ROYAL AUTOMOBILE CLUB

Form of recognition in accordance with appendix J to the International Sporting Code of the
FEDERATION INTERNATIONALE DE L'AUTOMOBILE

Manufacturer FORD MOTOR COMPANY LIMITED Cylinder-capacity 1601 cm.³ 97.55 in.³
Serial No. of chassis/body BB49KL 11059 Model ESCORT RS 1600
Serial No. of engine HE 1001 Manufacturer FORD
Recognition is valid from 1st October 1970 Manufacturer FORD
The manufacturing of the model described in this recognition form started on 11 January 1970
and the minimum production of 1000 identical cars, in accordance with the specifications of
this form was reached on 1st September 1970 List 1970/10

Manufacturer FORD
Model Escort RS 1600
F.I.A. Recognition No. 1605/111V
Amendment No. 1

A

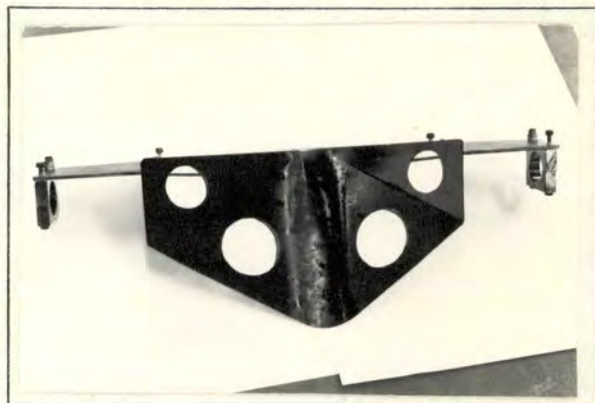
- A. Alternative Halfshaft Part No. CD 238P024
- B. Rear axle diff protection shield and plate Part No. FC 008
- C. Triple plate clutch Part No. CP 2289
- D. Modified bearing caps
- E. Alternative rear caliper ref amendment (2)
- F. Alternative wing extension

PICTURE I

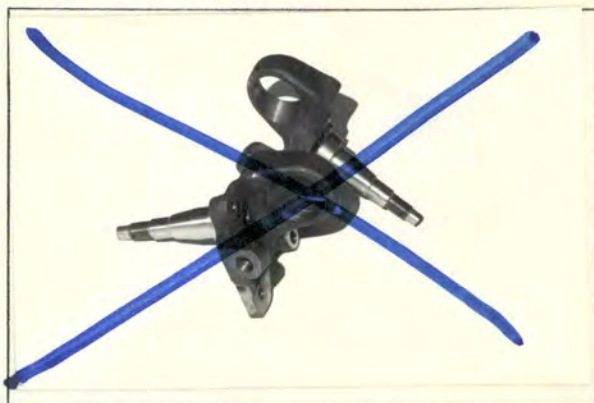
No.	Reference No.
	<u>GROUP II VARIANT</u>
	Alternative Flywheel Part No BA 0298 160 Wt. 4.1 kilo 9 lbs Picture <u>1</u>
	Brakes of different type and dimensions See Picture <u>III</u> Ref Amendment 11/11V
	Alternative Halfshaft Ref Amendment 9/9 Alternative Supplier Length and size dimensions identical Slight variation of forging See Picture <u>IV</u>

Photo 1

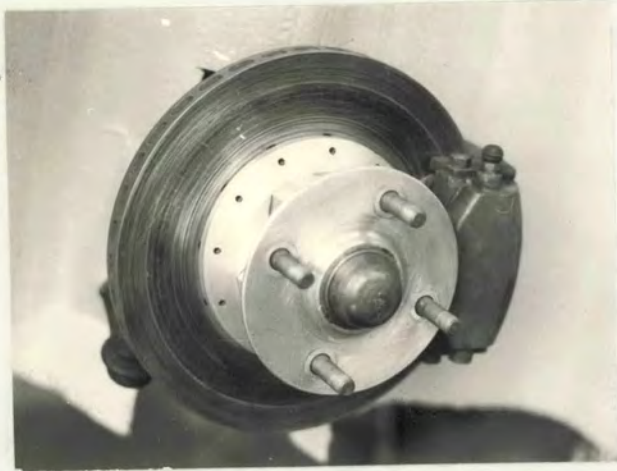
No.	Reference No.	
	Ventilated brake disc front	Part No 90 51671/2
	Outside dia: 11,67 ins	29,65 cm
	Photo No 1	
	Alternative supplier	
	Brakes of different type and dimensions which include larger hubs, stub-axles and wheel hubs	
	ventilated brake disc front	Part No 9050 981 A/B
	outside dia: 11,97 ins	30,4 cm
	Photo No 2	
	light metal brake caliper	Part No 9050 987 A/B
	brake area per wheel: 9,0 sq ins	58,06 sq cms
	No of pads per brake: 2	
	Photo No 3

Photo D,76.1

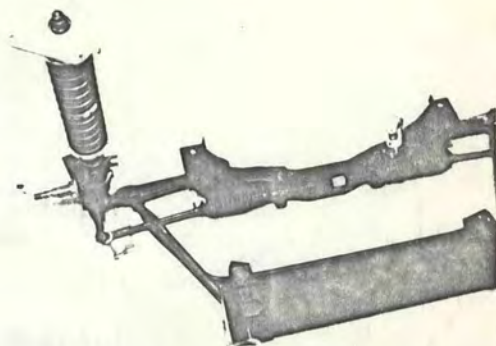
Reinforced front suspension

G77/4

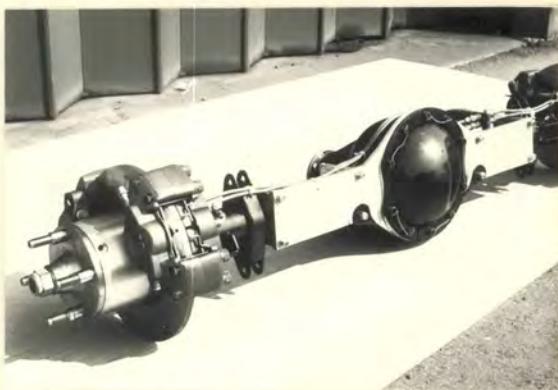
| | Reinforced heavy duty rear axle, see photo G77/4 |
